MAZDA DEALER EMAIL

June 11, 2024

This new repair is outlined in TSB 01-005/24, which will replace the current TSB 01-005/23.

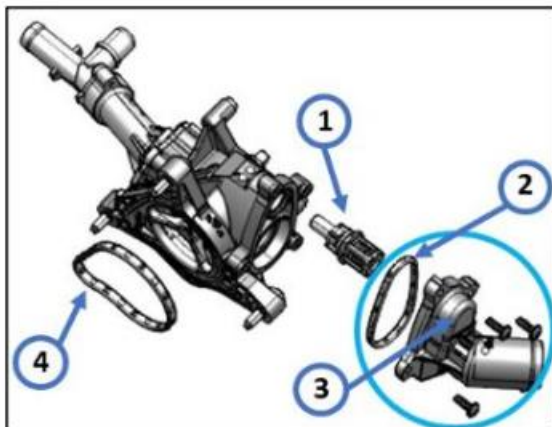
A new repair procedure has been developed to address DTC P0126:00 on SKYACTIV-G 2.0/2.5L engines. Mazda has introduced a replacement kit of the thermostat located within the Coolant Control Valve (CCV). It is no longer necessary to replace the CCV for this DTC.

- 1. Thermostat
- 2. Thermostat cover gasket
- 3. Thermostat cover
- 4. Water outlet gasket
